Newsletter Technology Center Ice Generators

July 2014

New bearing arrangement for machines F200 to F600

New stainless steel housing bearing arrangement

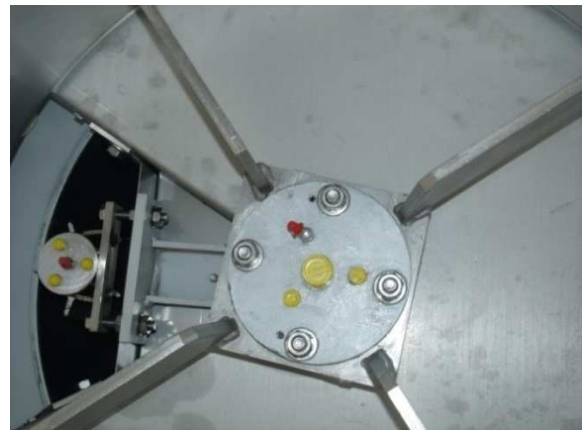
A new bearing arrangement is now used for the ice generators F200 and F250, this new bearing arrangement is described as an housing bearing arrangement.

Since the 1.07.2014 these bearings are supplied in stainless steel on all our F200, F250 & F600

It has to be noticed that these two bearing arrangements are not exchangeable, the new version cannot be installed on old machines. The following machines are concerned, the F200, F250, F600 ABF& SBF, PACKS 31 to 40.
